Figure 9: Biodiversity Impacts at Facilities Site (Proponents' Preferred Project Report, May 2009)

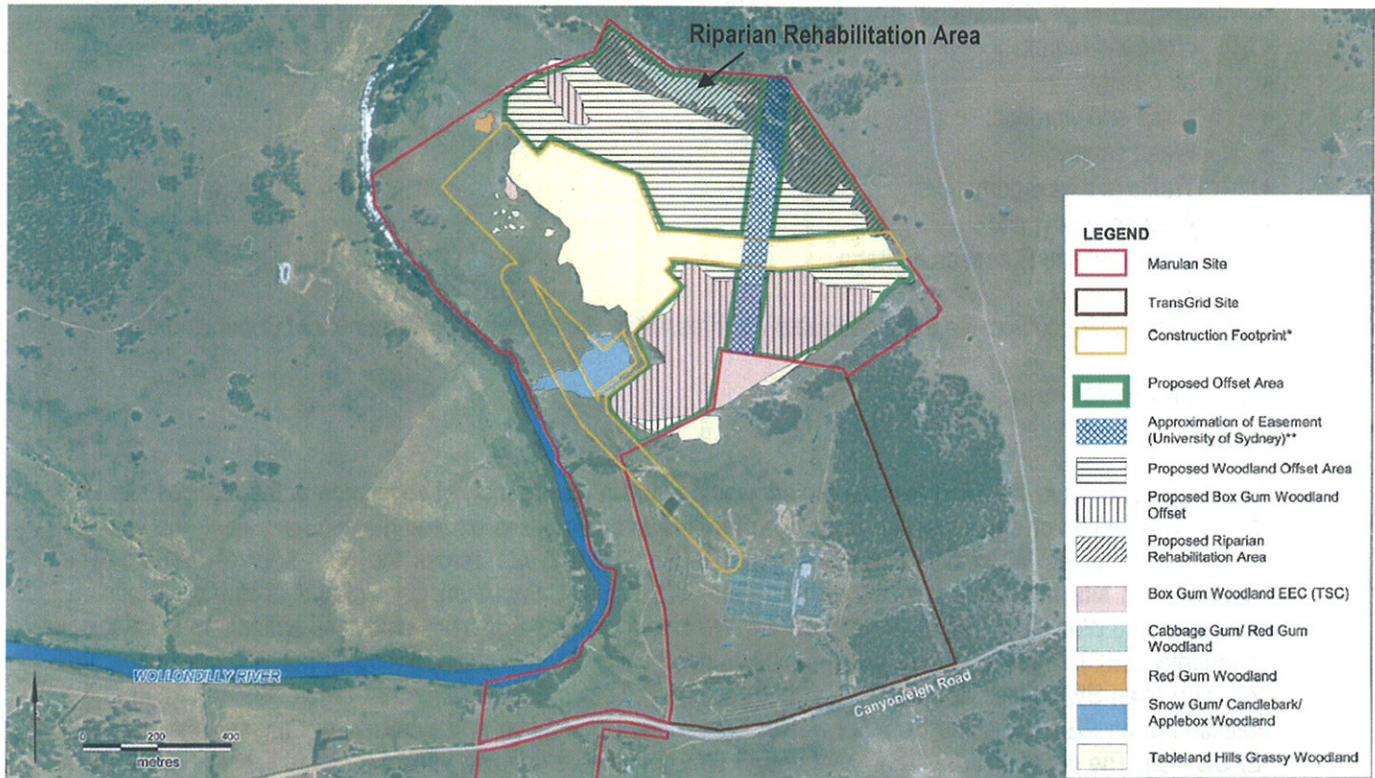
In addition, the Proponents have proposed a biodiversity offset package totalling 44.9 hectares to offset the residual impacts of the project, comprising (refer Figure 9):

- the rehabilitation of nine hectares of riparian vegetation along the existing degraded drainage line on the northern side of the facilities site;
- the permanent conservation of 35.5 hectares of native vegetation within the facilities site comprised of 13.8 hectares of Box Gum Woodland EEC and 21.7 hectares of Tableland Hills Grassy Woodland. Due to an existing but as yet undeveloped transmission line easement that runs through the facilities site from the adjacent Sydney University owned land to the TransGrid switchyard, the proposed offset will not comprise a single consolidated area but rather four separate unconnected sections (refer Figure 9). The Proponents have committed to ongoing discussion with Sydney University to determine the future of the easement including whether this additional land (4.5 hectares of native vegetation) can be incorporated into the Proponents' offset package to reduce fragmentation of the vegetation to be retained on site and increase the extent and the long-term viability of the total offset package; and

With respect to avoidance of unnecessary biodiversity impacts within the facilities site, the Department accepts that the configuration presented constitutes what can be reasonably achieved given the constraint of a 150 metre buffer from the Wollondilly River as required by the Sydney Catchment Management Authority (SCA) to avoid potential water quality impacts to Sydney's drinking water catchment as well as the need to minimise flood risk by locating above the 1 in 100 ARI flood level. Furthermore, the Department accepts that the proposed location of ancillary facilities within the facilities site constitute what can be reasonably achieved given the constraints associated with the less vegetated areas of the site including:

- proximity to the TransGrid switchyard making locating the gas pipeline along the western side of the TransGrid switchyard unfeasible due to potential electricity conductivity and associated corrosion risks; and
- inadequate space and unsuitable topography for vehicle transport, flood inundation risk as well as electricity conductivity related construction risks from the proximity to the TransGrid switchyard making locating the access road to the western side of the TransGrid switchyard unfeasible.

The Department notes that the Proponents have made several refinements to the facilities site configuration to minimise impacts to identified EEC onsite. On the above basis, the Department is satisfied the Proponents have given due consideration to avoiding biodiversity impacts within the facilities site, where possible balanced with other existing constraints on site. To ensure that a design principle of biodiversity impact avoidance is maintained during detailed design the Department has recommended conditions of approval requiring the Proponents to minimise the vegetation clearing required for the siting of the project as far as reasonable and feasible (including for the construction lay-down areas).

Notwithstanding the opportunity for further reducing vegetation impacts during detailed design, the Department accepts that the configuration identified by the Proponents would likely represent the worst case level of clearing that would be required at the facilities site. In this regard, the Department has considered whether the Proponents have demonstrated that reasonable and feasible options exist to offset this impact. The Proponents' offset package largely comprises the retention of vegetation on site that would not otherwise be disturbed by the development of the facilities, as well as the rehabilitation of an additional nine hectares of disturbed riparian vegetation on site and the conservation of a small remnant of Box Gum Woodland EEC within a separate property (Lot 153 – refer Figure 10) to the facilities site. Whilst in simplistic terms the Department accepts that the amount of native vegetation provided in the offset package (44.9 hectares) would be greater than the native vegetation to be cleared on site (16.1 hectares), the Department does not consider that the package would offset the biodiversity values of the facilities site consistent with the principles of "improve and maintain" for the following reasons:

- the vegetation to be impacted whilst not comprising EECs in all cases, nevertheless constitute vegetation of high conservation value as it comprises habitat for a number of threatened species and in the case of the Tableland Hills Grassy Woodland community comprises an "over-cleared" vegetation type in the region (i.e. 99% cleared);
- the offset land within the facilities site would comprise up to four fragmented remnants rather than a consolidated area and would be subject to degradation of biodiversity values through edge effects; and
- the small area of EEC provided in a separate block (Lot 153) is unlikely to maintain its biodiversity values if it is to be managed in isolation to the remainder of the block which may be subject to future development.

In response to the Department's concerns, the Proponents have proposed the inclusion of additional vegetated areas within Lot 153 (13 hectares in total including the EEC) into the offset package as a buffer to the 0.4 hectares of Box Gum Woodland EEC already proposed as part of the package. The Proponents have proposed Lot 153 as an alternative across which the western/eastern pipeline routes could traverse (refer Figure 10). Should this pipeline alternative be progressed, the Proponents have proposed the inclusion of an additional 2.75 hectares of vegetation (including 0.5 hectares of Box Gum Woodland EEC) located on a separate block also owned by the Proponents (Lot 31) into the offset package to compensate for any associated fragmentation impact that may result within Lot 153. The Department considers that the additional 13 to 15.75 hectares of land would provide a suitable offset, noting that the land includes vegetation of high conservation value including listed EEC which would be protected in perpetuity.

The Department is satisfied that the addition of these lots in conjunction with the measures to be implemented by the Proponent to minimise and mitigate flora and fauna impacts, would be sufficient to ensure that the biodiversity impacts of the facilities site are offset consistent with the principles of "maintain or improve". On this basis, the Department is satisfied that viable options exist to offset the impacts of the facilities site under worst case and that suitable mechanisms (such as voluntary conservation agreements) exist to secure the conservation values of the offset land in perpetuity. The Department has recommended a condition of approval requiring the Proponents to secure the offsets as proposed prior to the commencement of construction of the facilities site.

Further to the above, the Department has recommended conditions of approval requiring the Proponents undertake the following measures to further strengthen the Proponents' offset and rehabilitation requirements:

- offset each hollow bearing tree impacted by the projects on a 1:1 basis;
- rehabilitate any waterways and associated riparian vegetation disturbed during construction to a standard equal to or better than existing' and
- rehabilitate any vegetated areas within the power station site cleared for temporary construction lay-down to a standard equal to or better than existing.

Figure 10: Vegetation Communities Traversed by the Gas Pipeline Routes with Lot 153 DP750053 Highlighted (Proponents' Preferred Project Report, May 2009)

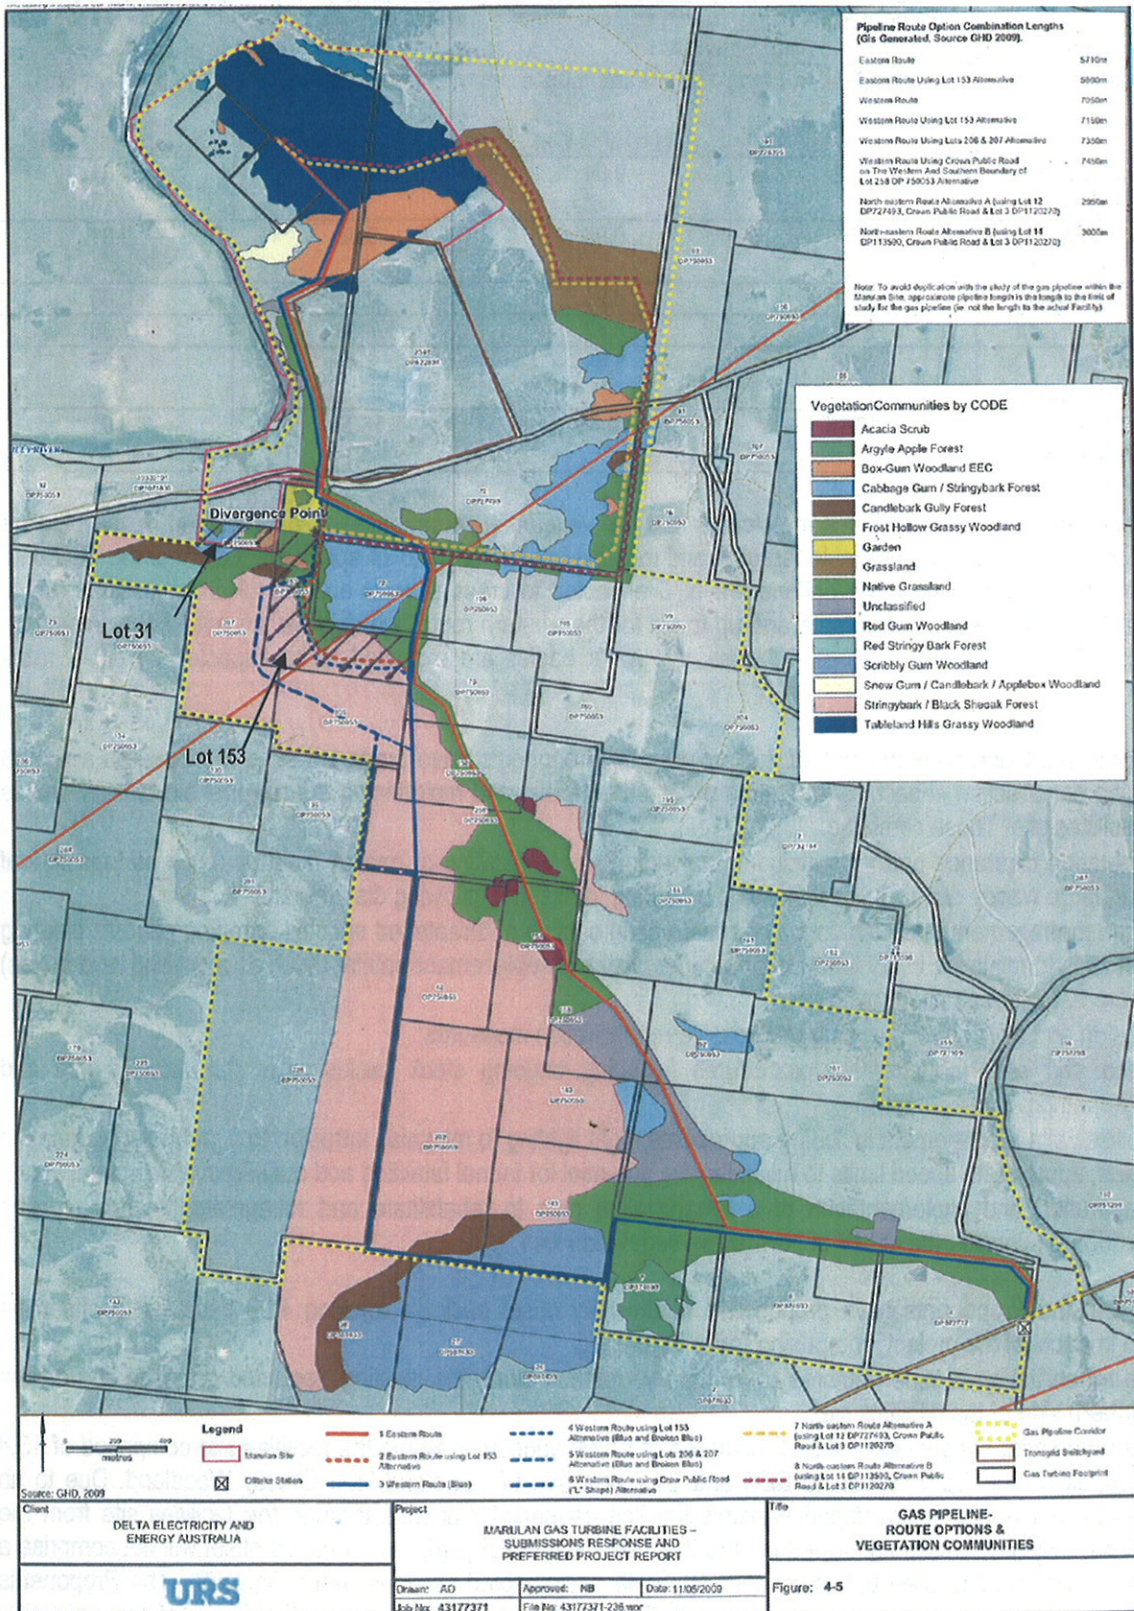
- the permanent conservation of 0.4 hectares of Box Gum Woodland EEC within a separate property (also owned by the Proponents) located to the south of Canyonleigh Road (Lot 153 DP750053 – Refer Figure 10).

With respect to biodiversity impacts, the Department considers that the western route has the potential to have significant impacts if not adequately offset. The Department considers that a high ratio of offset is likely to be required to ensure that the disturbance is adequately compensated consistent with the principles of "maintain or improve" given:

- the nature of vegetation to be cleared which comprises listed EEC and suitable foraging and/ or roosting habitat for up to 24 listed species;
- the nature of proposed clearing which would involve the bisecting and fragmentation of a large area of existing, well established, regenerated vegetation with the potential for ongoing degradation and edge effect impacts (even after rehabilitation) through operational maintenance activities along the pipeline corridor; and
- the extent of vegetation clearing comprising at worst case up to 9.45 hectares of native vegetation.

Whilst the Department accepts that the biodiversity impacts of the western route could in principle be offset to ensure no net loss of biodiversity values in the long term, the Department considers that where a feasible alternative exists which would enable the impact to be avoided rather than offset this alternative should be pursued in the first instance. In this regard, the Department considers that the pursuance of development options within the western section of the gas pipeline route would only be warranted where all reasonable and feasible route options within the eastern section have been exhausted. In the current case, the Department considers that the route options identified in the eastern section provide just as technically feasible options as the western routes whilst posing clear advantages with respect to biodiversity impacts and not posing any significant constraints in other respects such as landuse. On this basis the Department has recommended that the Minister use her discretion under Section 75O(4) of the *Environmental Planning and Assessment Act 1979* to modify the concept

plan approval to remove the western part of the gas pipeline corridor which traverses vegetated areas, whilst providing concept plan approval for the eastern section of the corridor. This approval regime means that development could only be pursued within the western sections of the pipeline corridor through a modification to the Minister's concept plan approval and only should the Proponents be able to demonstrate that all reasonable and feasible options within the eastern section (aimed at avoiding biodiversity impacts) have been exhausted and that viable options exist to offset the biodiversity impacts of a western route option.

With respect to the specific biodiversity impacts of the eastern gas pipeline route, the Department considers that even under worst case, the biodiversity impacts of this route (i.e. 3.28 hectares) are unlikely to be significant as it would be largely confined to scattered stands of vegetation within already cleared (pasture) areas or at the edge of the adjacent intact area of vegetation. The Department is satisfied that the offset measures proposed as part of the facilities site in conjunction with the pipeline rehabilitation measures proposed by the Proponents would be sufficient to offset the biodiversity impacts of this route. In this regard the Department notes that the total offset (57.5 to 60.25 hectares) for the native vegetation to be impacted by project (19.38 hectares comprising the facilities site + the pipeline) would be in the order of three hectares to each hectare impacted (3:1 ratio). The Department is satisfied that the minor waterway crossings associated with the pipeline would not result in a significant impact to aquatic or riparian values as all of the waterways to be crossed comprise ephemeral drainage lines that do not support any water or aquatic vegetation and which have in most cases been highly modified and eroded from surrounding agricultural practices including grazing and weed infestation. Whilst some riparian vegetation may require clearing at up to three drainage lines this would be subject to appropriate rehabilitation to ensure no net loss of ecology values. In this regard, the Department has recommended a condition of approval requiring all watercourses disturbed during construction to be rehabilitated to a standard equal to or better than the existing condition in consultation with relevant agencies.

On the above basis, the Department is satisfied that there are no biodiversity constraints to recommending full project approval for each of the eastern pipeline route alternatives identified. Full project approval for each of eastern route alternatives (including north eastern options) within the broader (eastern) concept plan corridor would provide the Proponents with maximum flexibility in determining a final preferred route as part of detailed design and easement negotiations.
